ALLEGHENY COUNTY SANITARY AUTHORITY

CONTRACT NO. 1759 G, E, H, P

ENVIRONMENTAL COMPLIANCE FACILITY

ADDENDUM NO. 4

Contract: 1759
 CAD File Name: 220C12.DWG
 Date: 01 / 14 / 2022
 Sheet: 13 of 287

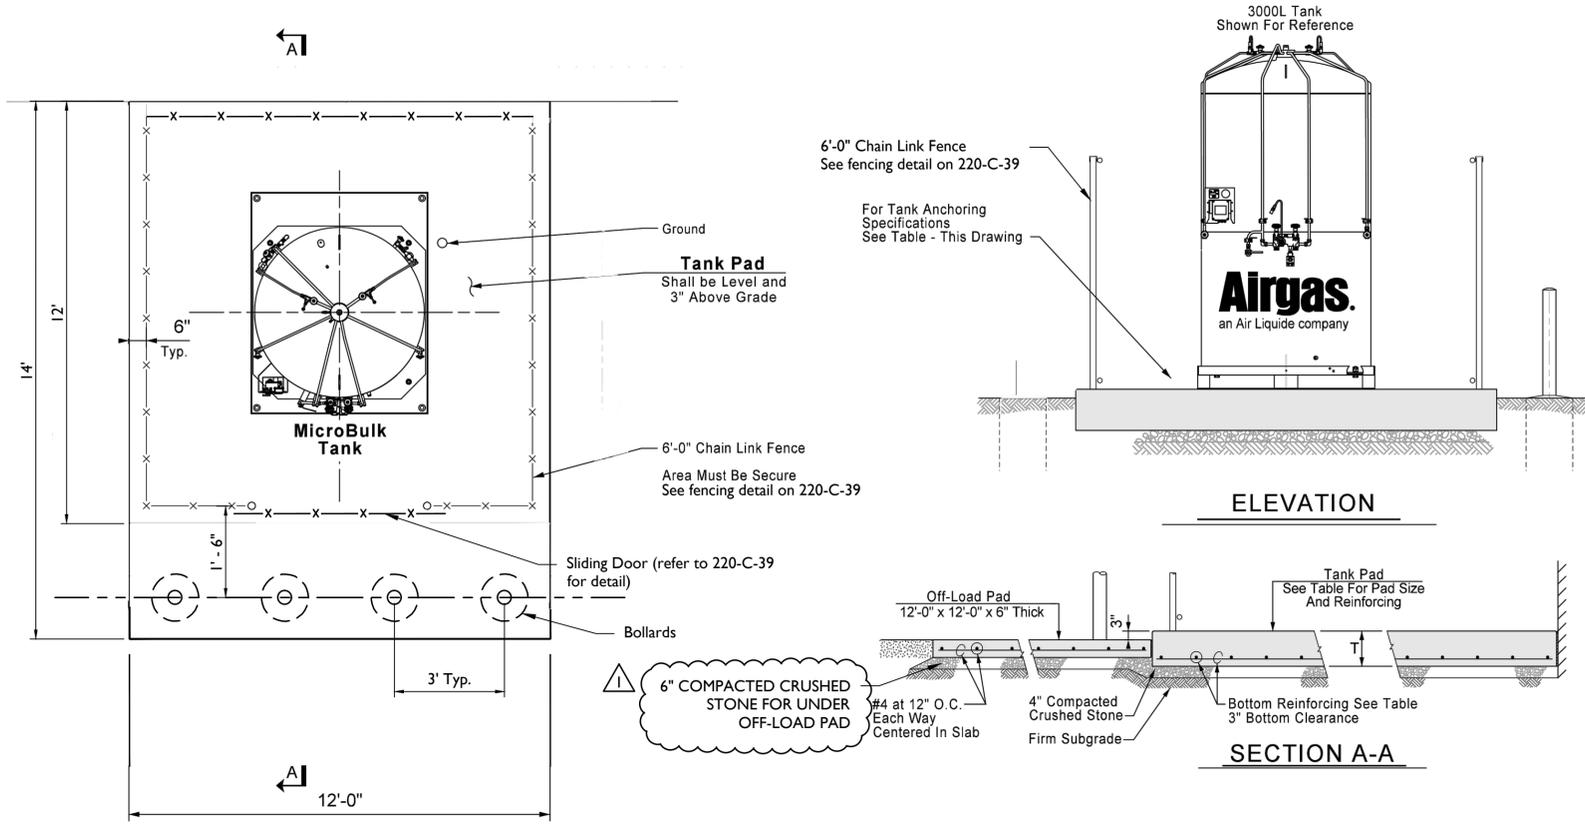
1. Drawing 220-C-12 – Demolition Plan
 - a. DELETE this drawing and REPLACE with the attached drawing 220-C-12
 - b. Updated Limit of Sidewalk labels
 - c. Extended the concrete loading pad to the gas pad.

Q51: On sheet C-12, there is a piece of sidewalk that connects to the parking garage that appears to be part of this project scope. There are 2 call outs for limit of curb line along the sides of the small piece of sidewalk, but there is not a double line to represent the curb like everywhere else. Are we to provide a curb on the sides of this piece of sidewalk between lawn areas?

Q59: Is there to be an off-load concrete pad adjacent to the Gas storage pads? If so, what size? Sheet C-38 shows a reinforced concrete off-load pad adjacent to the tank storage pad, but sheet C-12 shows a slightly extended trash enclosure pad but it is not along the entire length of the gas storage pads.

1 FOUNDATION PLAN
1/8" = 1'-0"

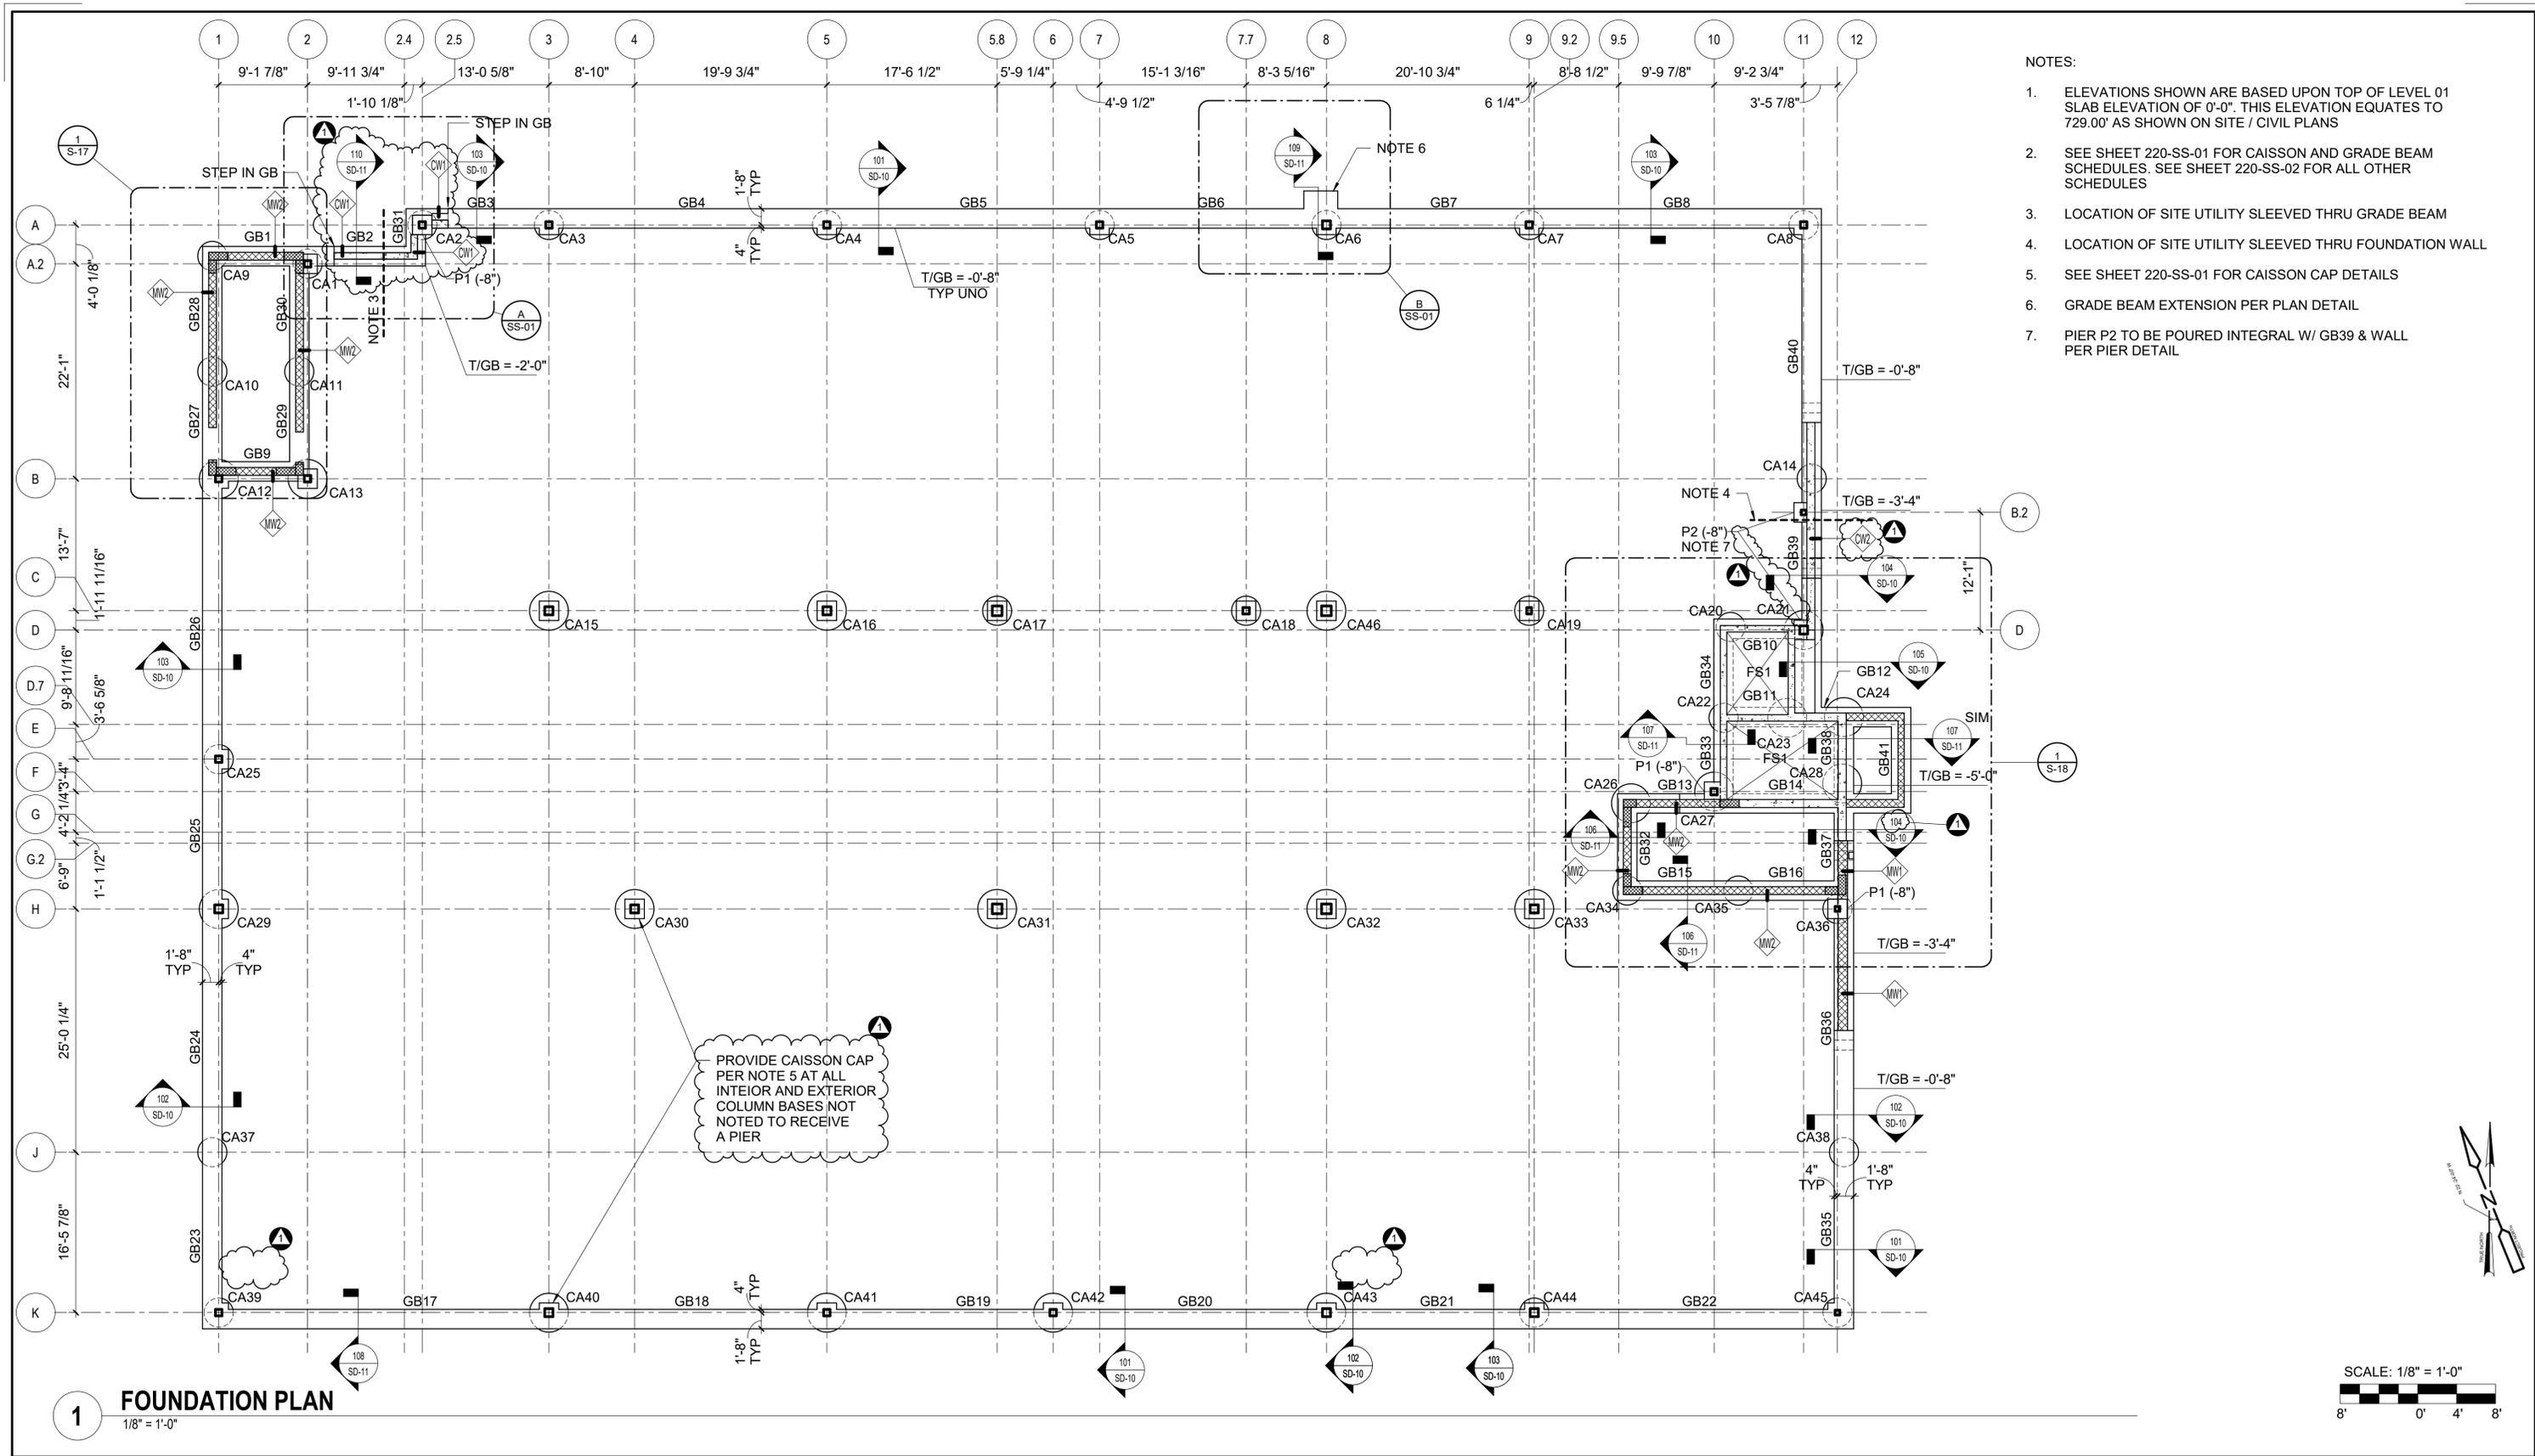
4. Drawing 220-S-10 – Foundation Plan
 - a. REPLACE with the attached drawing 220-S-10.
 - b. Clarified piers and caissons caps.
 - c. Added a foundation wall near column A-2.4 and updated section mark.

Q27: There are several locations where concrete piers are required and appear on drawing 220-S-10 but do not indicate a pier type. An example would be along K line for columns in between the two piers that are called out at P1. There are similar cases elsewhere. Please clarify.

A27: This will be clarified within Addendum #4 drawings. Piers noted at K-1 and K-8 are incorrect and will be deleted. All other piers noted are correct. At all interior and exterior column locations supported by caissons, a caisson cap is required per details on sheet 220-SS-01.
